UNITED STATES PATENT AND TRADEMARK OFFICE

Office Action Summary	Application No.		Applicant(s)	
	10/064,010		VLACHOS, GEORGE J.	
	Examiner		Art Unit	
	Henry M. Johnson, III		3739

SUPPLEMENTAL ACTION

FIG 3

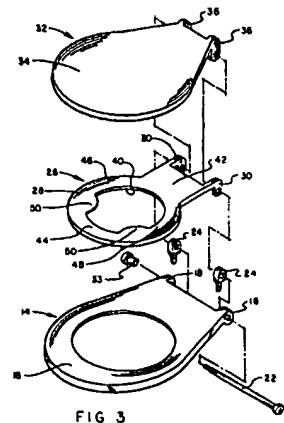
Claim 11 is rejected under 35 U.S.C. 103(a) as being unpatentable over U.S. Patent 2,460,543 to Spierer in view of U.S. Patent 5,384,917 to Epling. Spierer is discussed above, but does not teach a second seat between the main seat and the cover. Epling teaches an auxiliary child's toilet seat (Fig. 3, # 46) that is mounted between a main seat (Fig. 3, # 16) and a cover (Fig. 3, # 34). The child's seat may be moved out of the way when not needed or desired.

made to mount the UV lights on an auxiliary seat as taught by Epling in the invention of Spierer to provide the option of a lighted or non lighted seat to the user.
